SYDNEY CENTRAL CITY PLANNING PANEL

COUNCIL ASSESSMENT REPORT

Panel Reference	PPSSCC-389
DA Number	DA/662/2022
LGA	City of Parramatta Council
Proposed Development	58 storey commercial office tower, ground level retail and 2 storey basement with 51 car parking spaces and 8 service bays; demolition of existing buildings; tree removal; landscaping; signage zones; and public domain works. This application will be determined by the Sydney Central City Planning Panel and is also nominated integrated development under section 90 of the Water Management Act 2000.
Street Address	89-91 George Street, Parramatta NSW 2150 (Lot 1 DP 505486 & Lot 1 DP 1050741)
Applicant	L Clancy
Owner	GPT Management (Custodian) Pty Ltd
Date of DA lodgement	24 August 2022
Number of Submissions	1
Recommendation	Refusal
Regional Development Criteria	Pursuant to Clause 2 of Schedule 6 of State Environmental Planning Policy (Planning Systems) 2021, the development has a capital investment value of more than \$30 million.

Figure 10. Applicant draft layout for ground floor frontage.

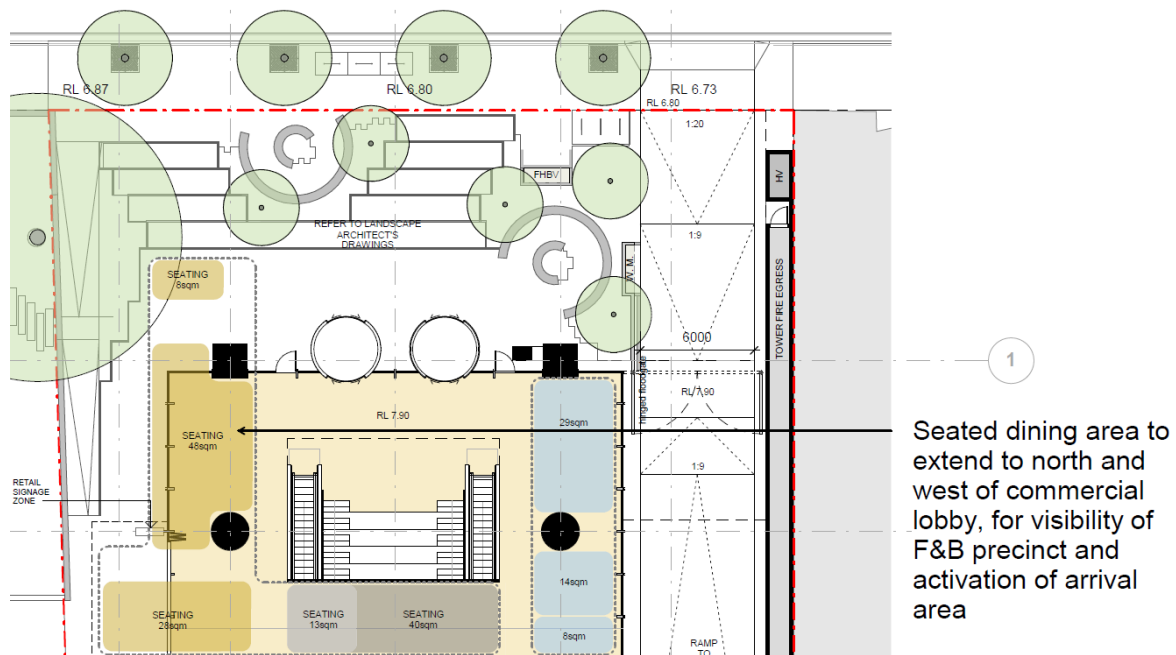
As is evident, the majority of the frontage is commercial lobby arrival space, with a small area of seating for a food and drink premises on the western side of the lobby and in the front setback. The area shown in blue is noted as a concierge area in other application documentation.

The proposal is not considered to provide sufficient activation for the following reasons:

- Due to the significant ground floor front setback (13.8m) and lack of frontage length, it is unlikely that the proposal will be sufficiently visible/inviting to attract pedestrian traffic in its own right. The majority of customers are likely to be from the office building.
- The proposal does not provide for a fine grain frontage. If the proposal included a podium, there would be sufficient width to provide distinct retail tenancies either side of the lobby, closer to the footpath, and thus more likely to activate and be engaged with the street and pedestrians passing by.

Figure 12. Site-specific DCP built form controls

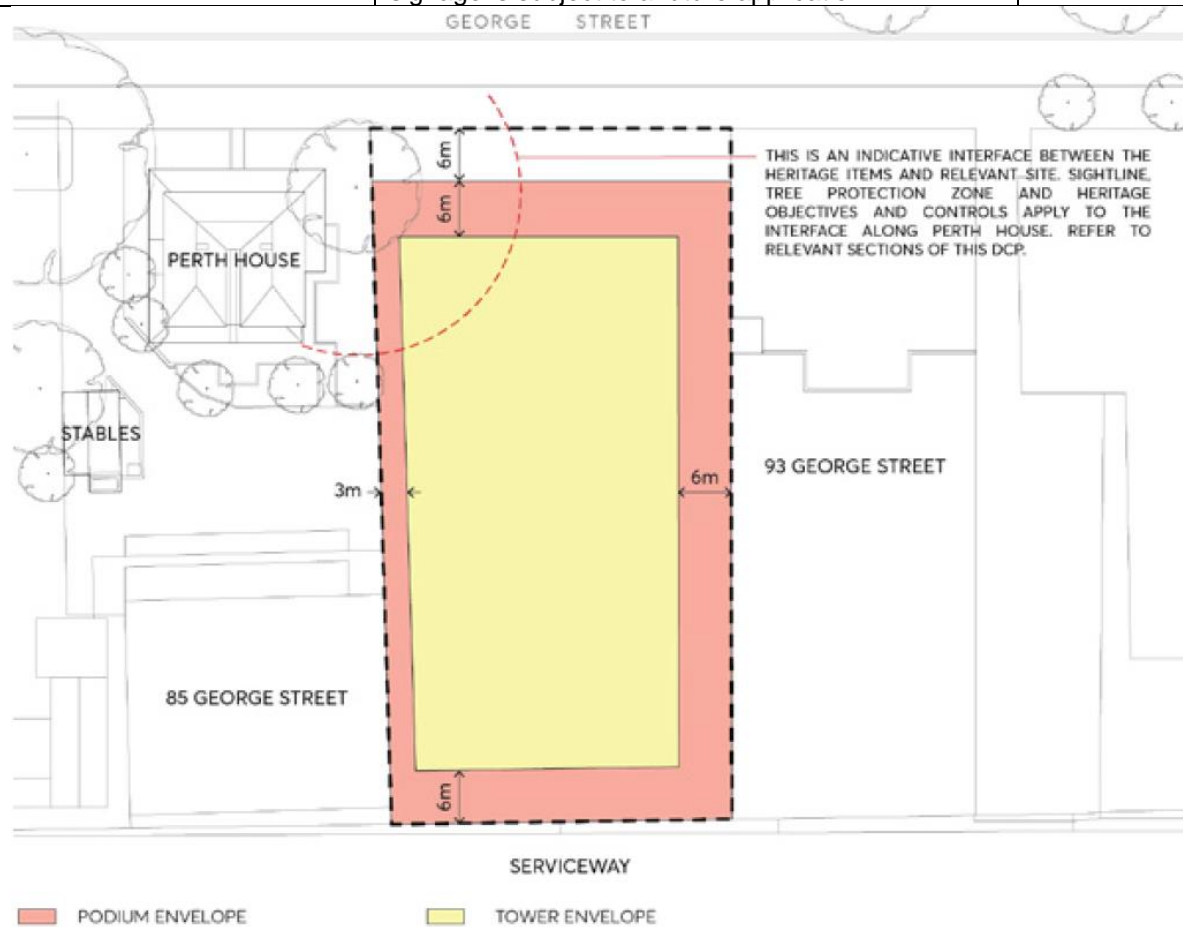
Built Form	(measurements to glass lines, do not include external shading)	
Setbacks:		
• North:		
o Podium: >6m	13.8m (ground floor – level 2)	Yes
o Tower: >12m	12.3m (level 3+)	Yes
• East		
o Podium: >0m	0m-9.0m (ground floor – level 2)	Yes
o Tower: >6m	6m (level 3+)	Yes
• South		
o Podium: >0m	1.0m-1.5m (ground floor – level 1)	Yes
o Tower: >6m	1.1m -6.1m (level 2+)	No
• West:		
o Podium: >0m	0m-5.8m (ground floor – level 2)	Yes
o Tower: >3m	1.1m -3.1m (level 3+)	No

Figure 13. Proposed green wall on eastern boundary.

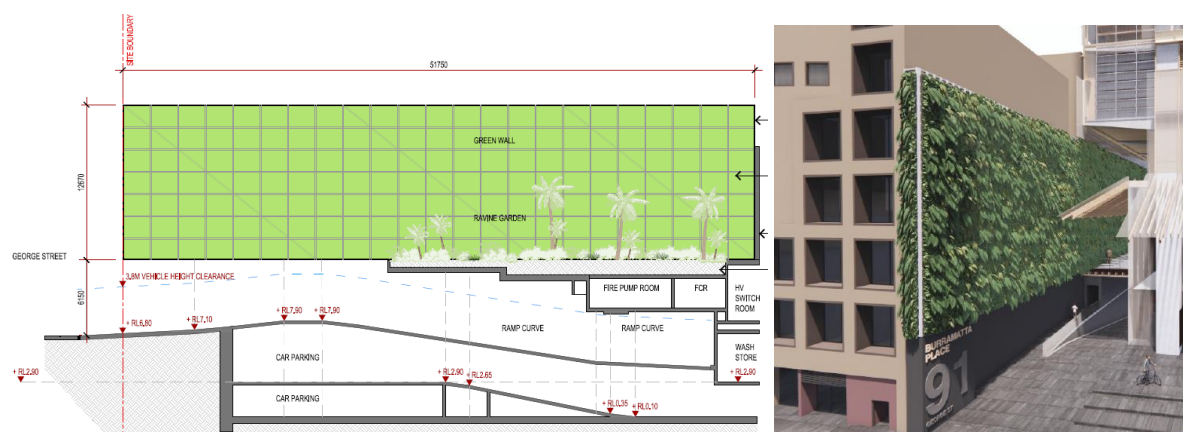
The green wall is not considered to be appropriate for the following reasons:

- The DCP sets out that green wall should be integrated into the design of new buildings. The proposed green wall is a distinct and stand-alone structure.
- The green wall is excessive in scale. Were the planting on the structure to fail, or were the wall to be poorly maintained, it would have a significant visual impact on the streetscape.
- The green wall appears to be a response to the large blank wall exposed on the adjoining site as a result of the lack of a podium and the significant setback of the lower levels. A podium with the street wall set back 6 metres would expose an acceptable extent of the well-constructed adjacent brick wall without need of any further treatment.

Figure 14. Entrance sequence for those arriving from the west, able to use stairs (green line) and unable to use stairs (orange line).

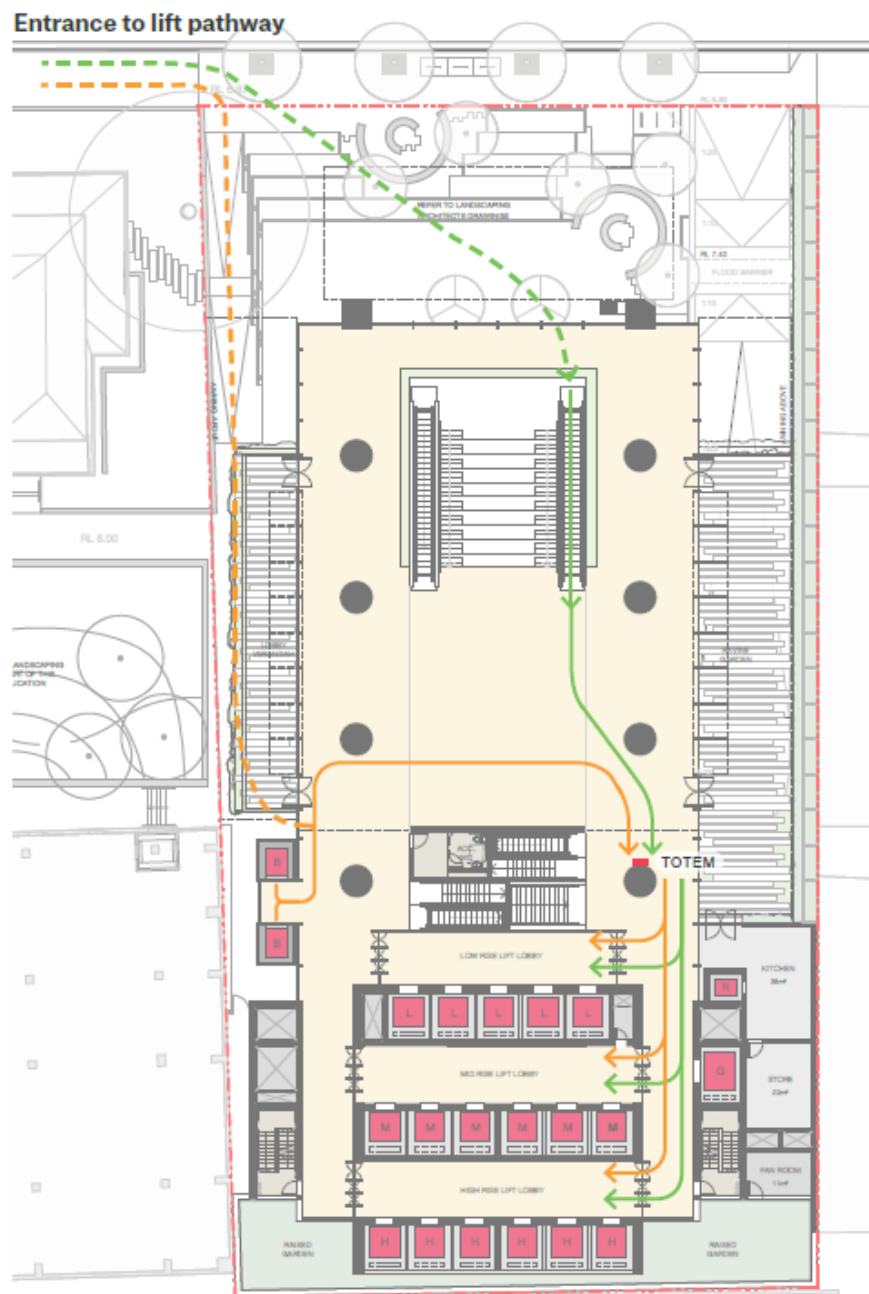
The proposal does not provide direct step-free access to the main entrance. Those unable to use the stairs in the front setback will need to enter the building via a secondary entrance at the rear of the western side elevation (see Figure 14 below). Further, the inclusion of the grand stairs, bleacher seating and escalators which occupy most of the lobby frontage result in an imposing blockage for persons who are unable to use stairs. While the proposal is supported by the applicant's accessibility consultant, Council's accessibility officer considers it to be unequitable. As such this forms reason to refuse the application.
